Generic Environmental Impact Statement for License Renewal of Nuclear Plants

Supplement 38

Regarding Indian Point Nuclear Generating Unit Nos. 2 and 3

Draft Report for Comment

3 **Figure 4-3. Percentage of entrainment composed of RIS fish and total identified fish**
 4 **relative to the estimated total entrainment at IP2 and IP3 combined**
 5 **(data from Entergy 2007b)**

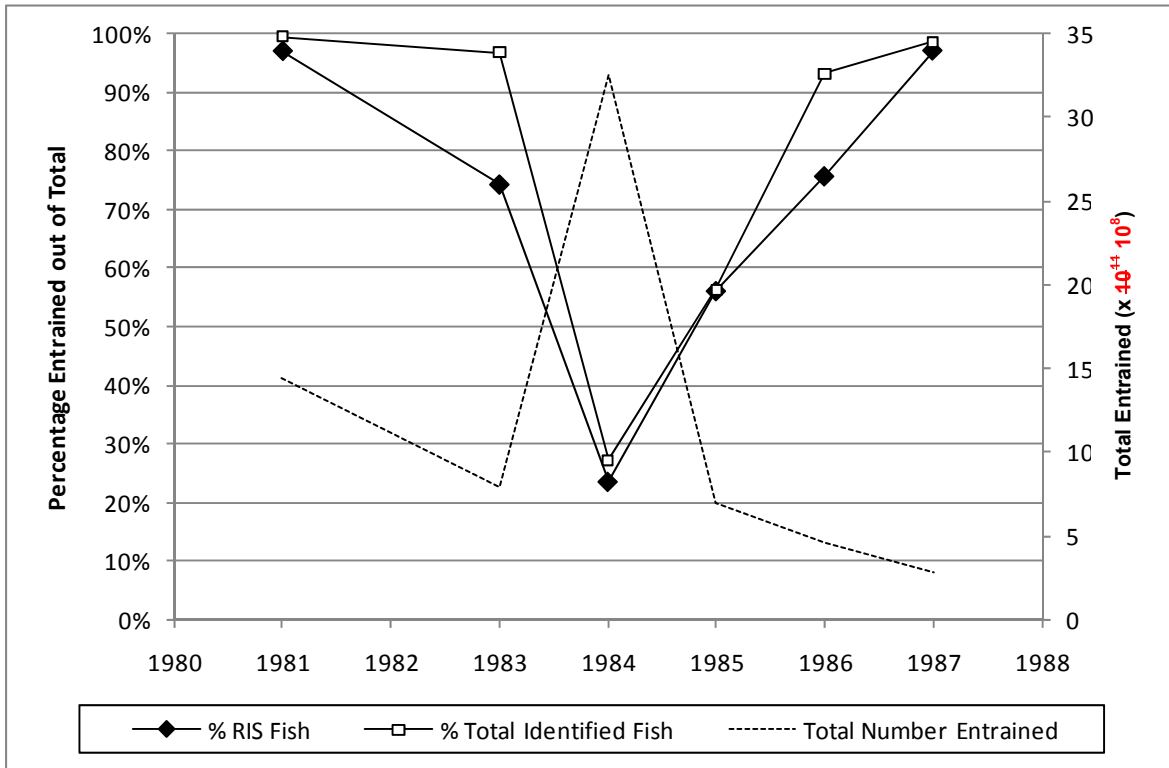
In the FSEIS, the NRC staff estimated the number entrained for a given week as the product of the mean density entrained and the combined weekly flow for IP2 and IP3. The error in the entrainment catch density directly affects Figure 4-3 in Section 4.1.2, and the error is repeated in Figure H-5 in Appendix H. In these figures, the total number entrained on the right axis should be in units of numbers $\times 10^8$ instead of numbers $\times 10^{11}$. The corrected Figures 4-3 and H-5 appear below. In addition, these changes affect two portions of text in the FSEIS.

1 **Figure 4-3 on page 4-15 in the FSEIS is corrected as follows:**

3
 4 **Figure H-5. Percentage of entrainment composed of RIS fish and total identified fish**
 5 **relative to the estimated total entrainment at IP2 and IP3 combined**
 6 **(data from Entergy 2007b)**

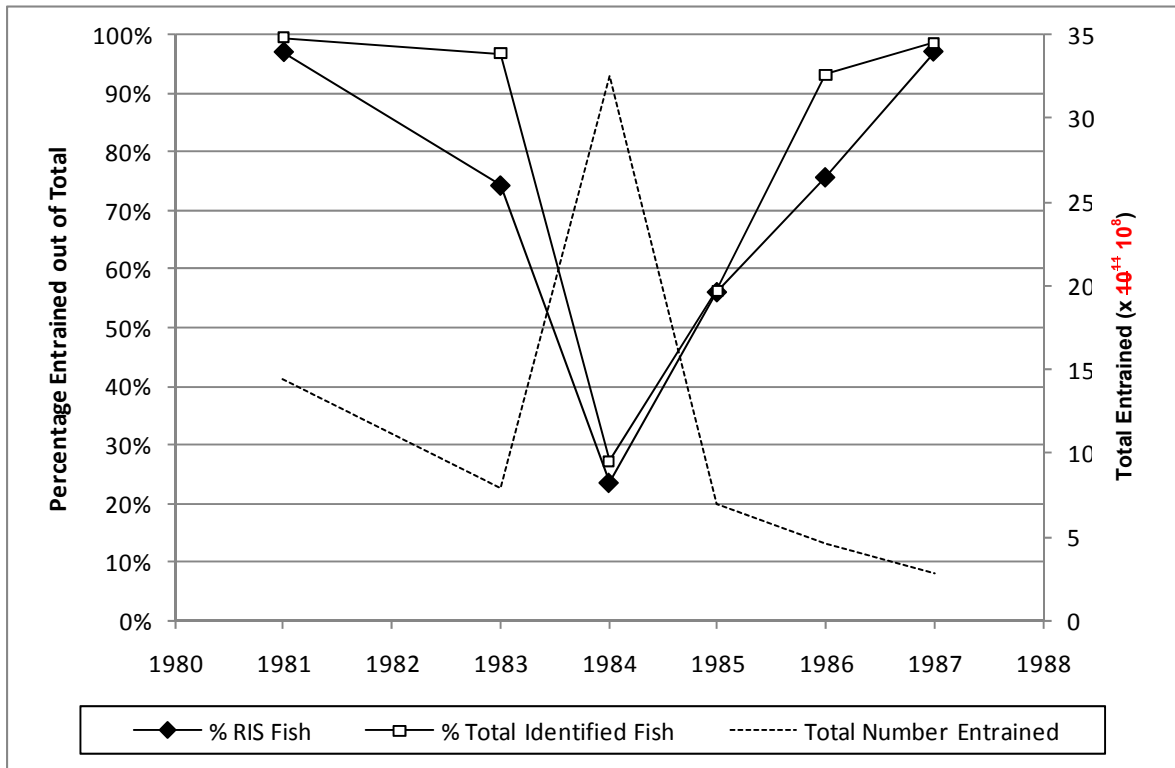
1 **Figure H-5 on page H-23** in the FSEIS is identical to Figure 4-3 in the FSEIS and is corrected
 2 as follows:
